# ADDENDUM No. 1

RFP No. 22-49

## Ellsworth Road Sidewalk Gap Elimination

DRAWING No. 2022007-21

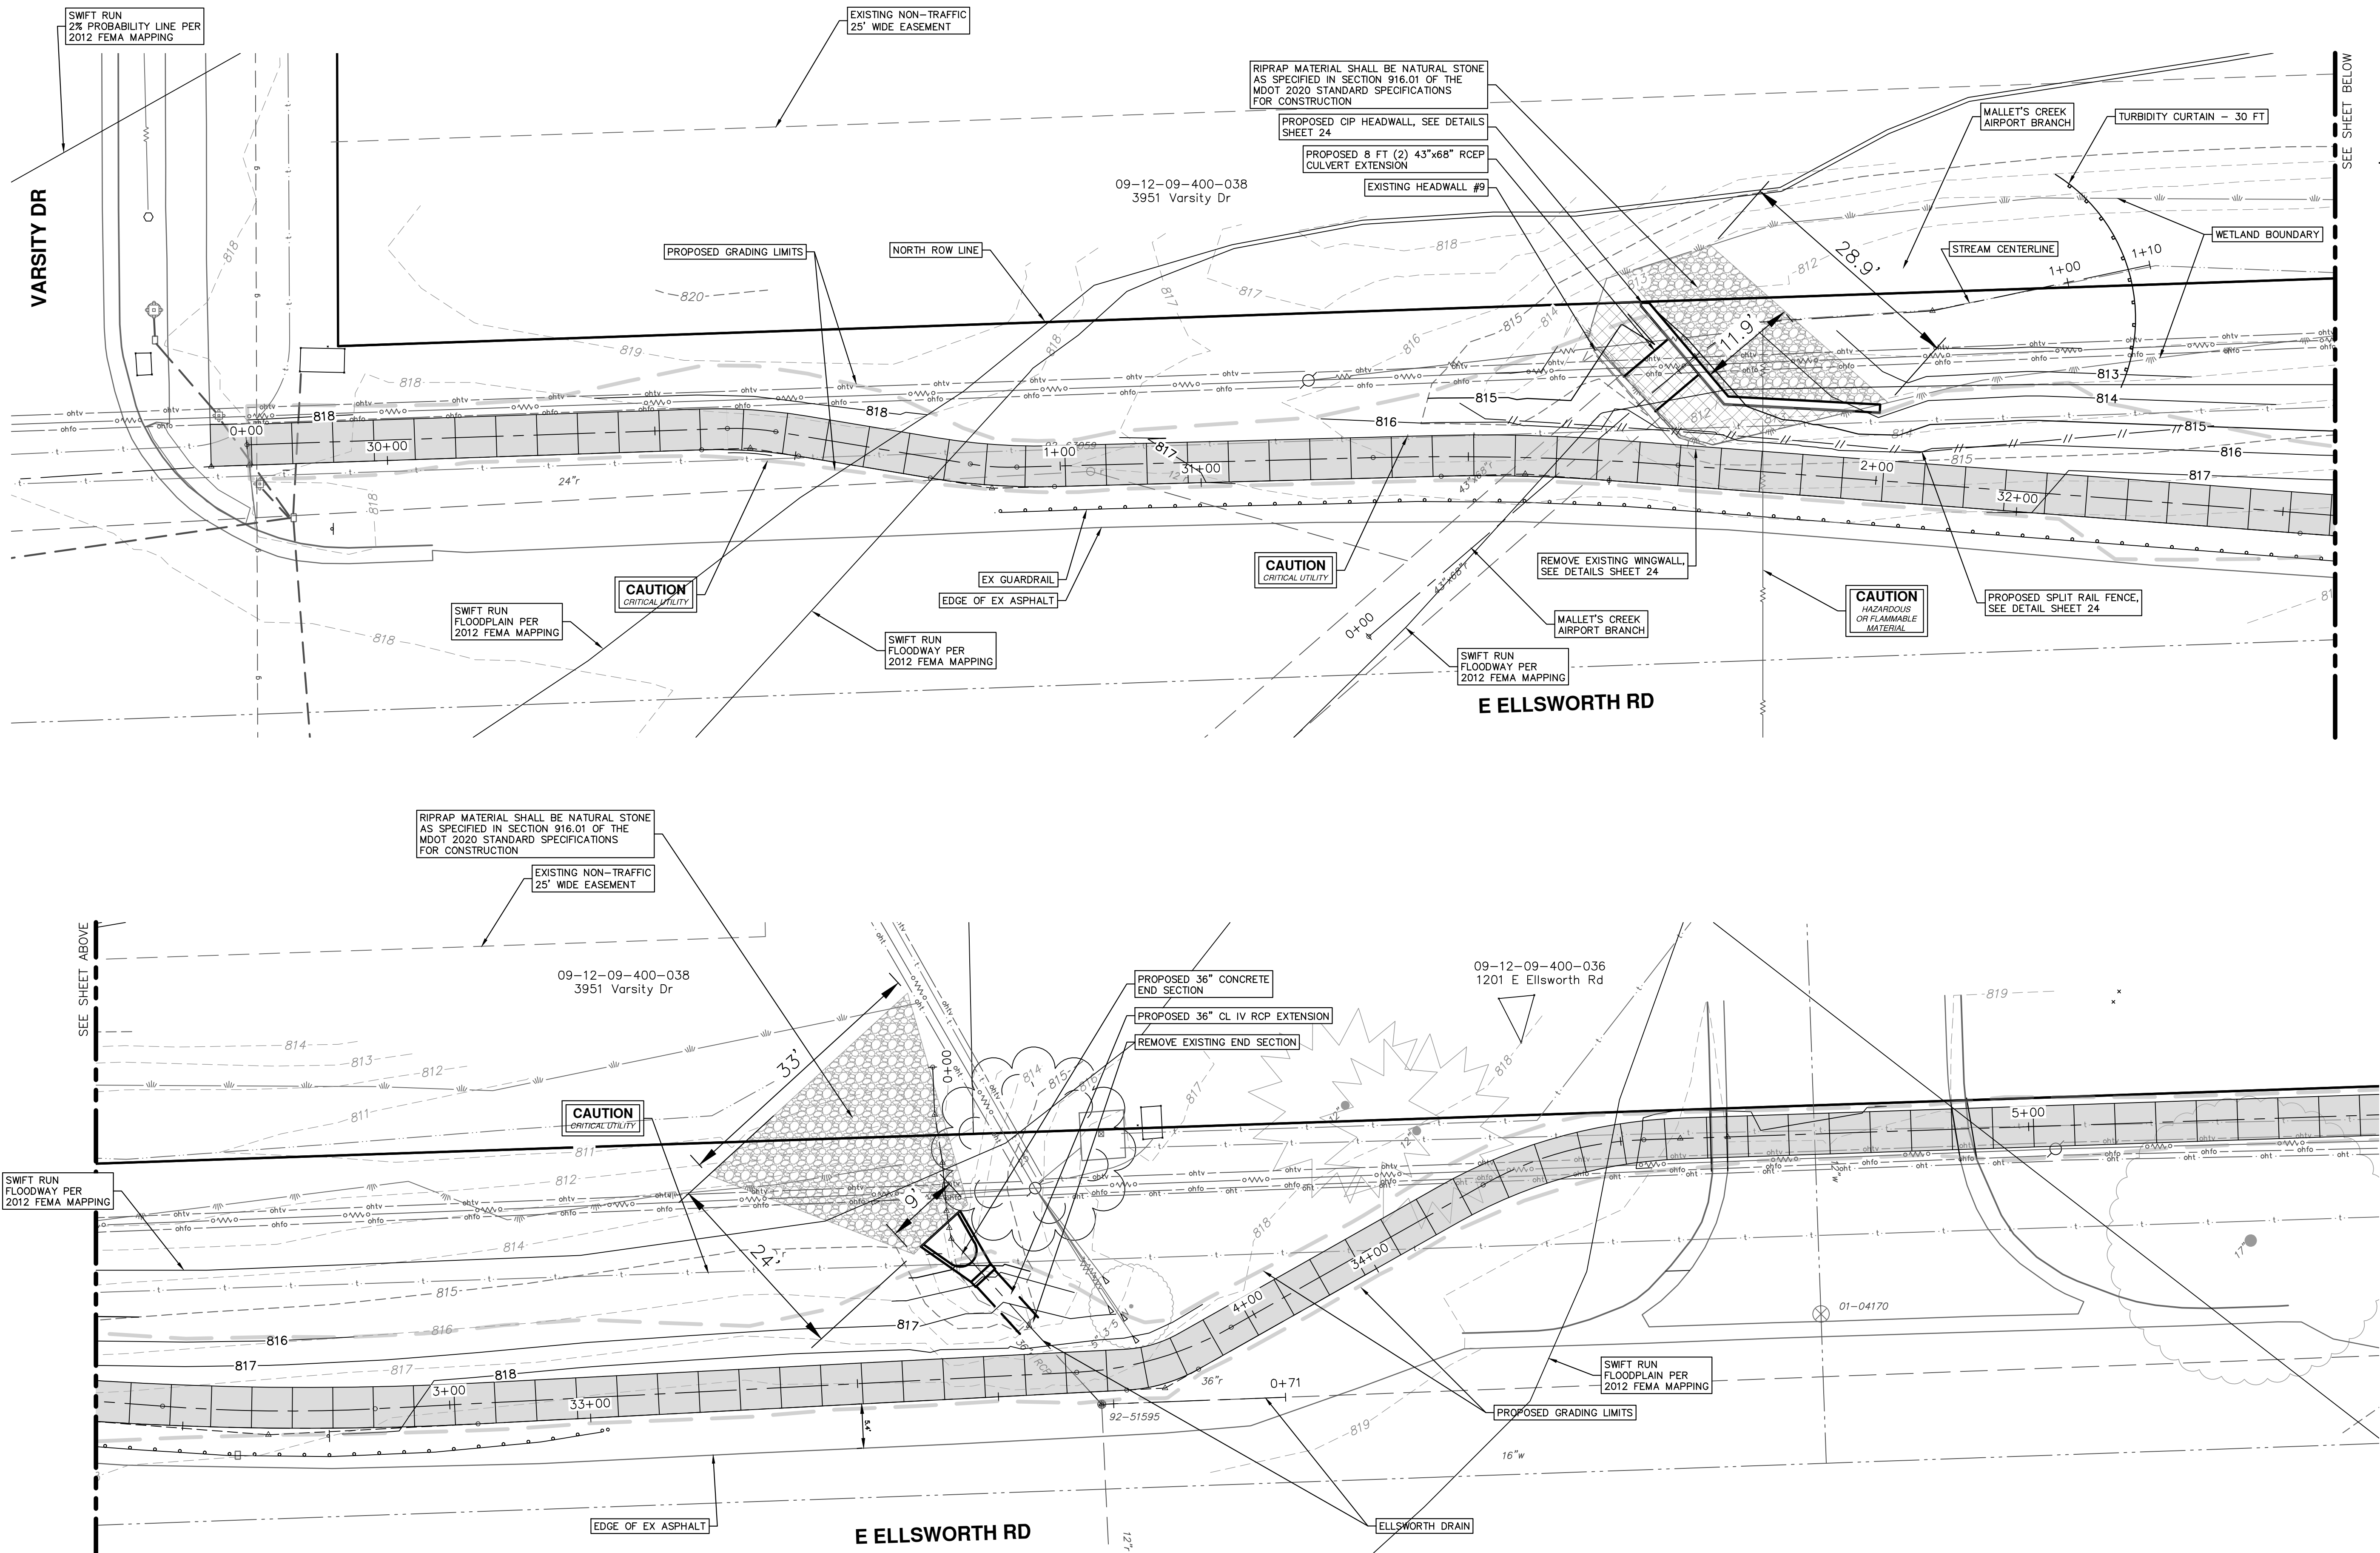
Drawing Plan / 13 of 24	Corrected Pay Item in Note Regarding Coordination with Ann Arbor Railroad
Drawing Plan / 21 of 24	15" Storm Sewer and End Section specified as Concrete

SCALE PLAN: 1" = 10'  
 DRAWING No. 2022007-22

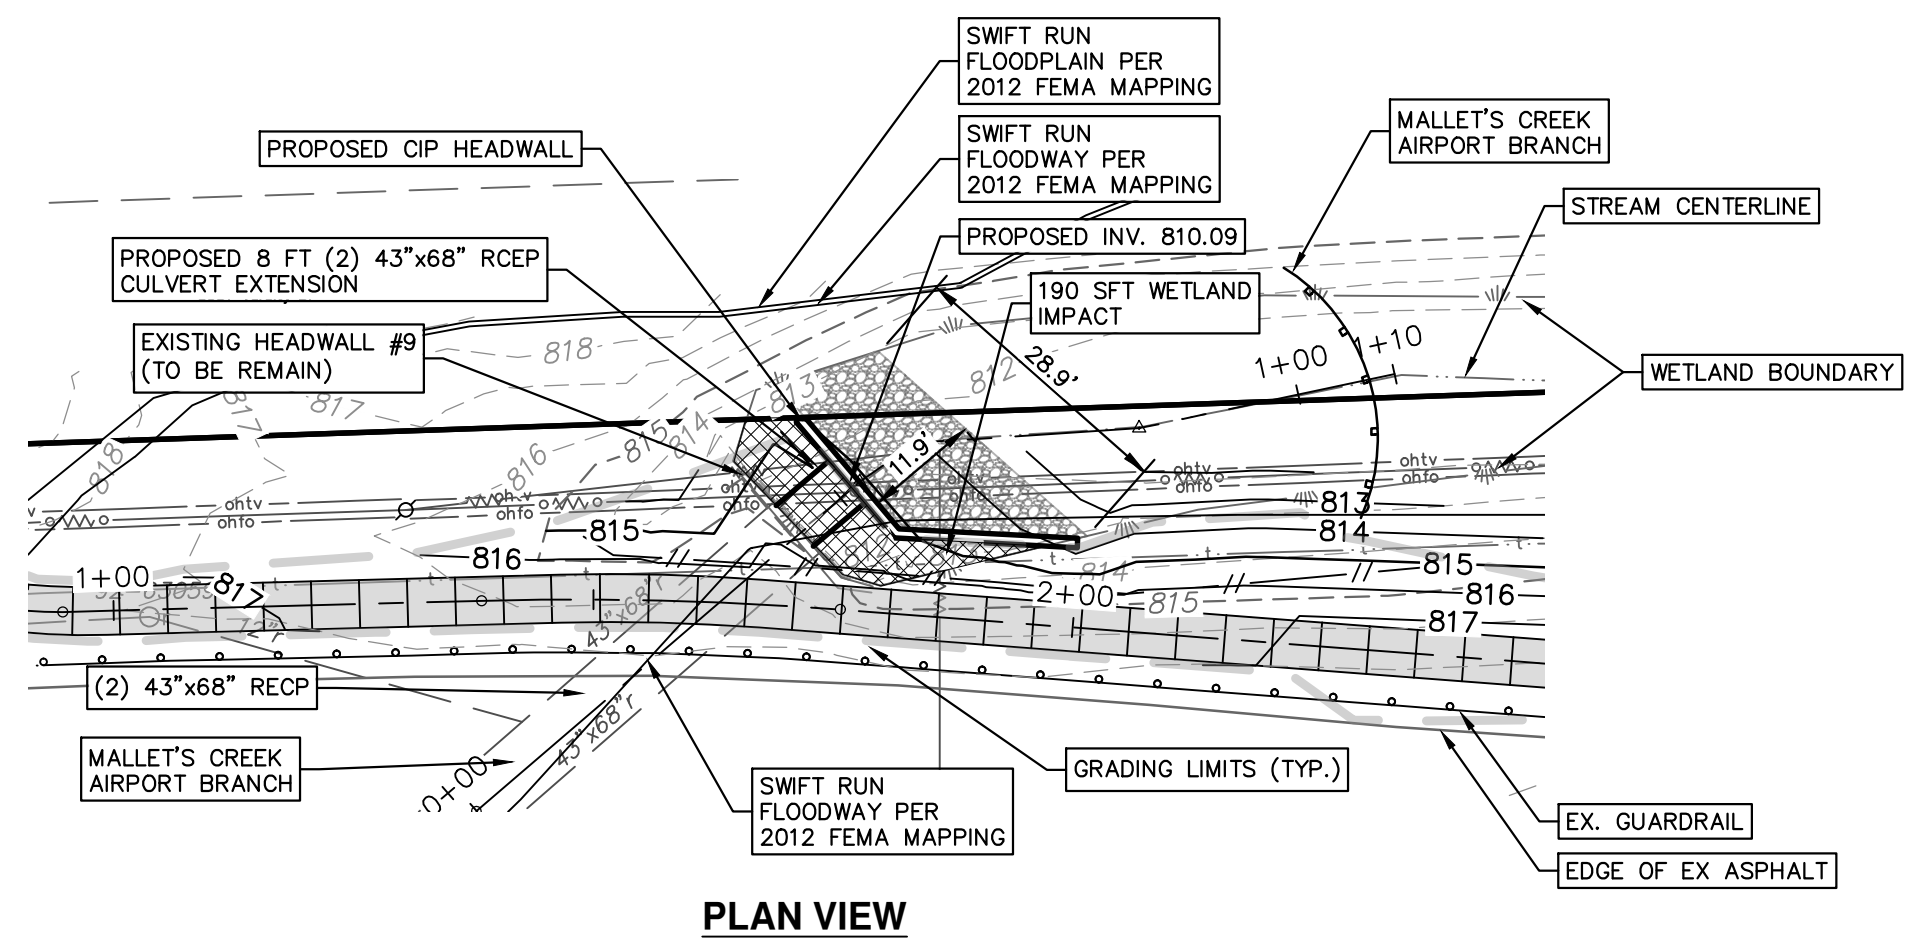
Drawing Plan / 22 and 23 of 24	Added Turbidity Curtain
Drawing Plan / 23 of 24	Added Sheet 23 to Plan Set (Previously provided in Appendix)
Drawing Plans / Multiple	Added Additional Easement Information Added Floodplain/Floodway Information Added Restoration Quantities and Native Seed Quantities Updated Sidewalk Type Quantities
<i>Comment: The intent with this change is to simply replace the plan set with Drawing Plans provided herein.</i>
